2. COA-063226-2019

STAFF REPORT

416 West Clay Street

Reconstruct a front porch and reinstall cast iron posts and railing.

Figure 4. Section of missing cornice.

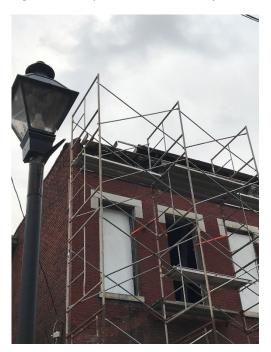
- The front porch roof profile be designed to match the ghosting on the façade, as well as the front porch roof at 414 West Clay Street.
- The metal roof be flat-lock or hand-seamed.
- The new porch include a box gutter and the applicant submit additional information for administrative approval.
- If any additional exterior work is required, the applicant work with staff to ensure the work is consistent with the Commission's Standards for Rehabilitation and submit an additional application for a Certificate of Appropriateness as necessary.
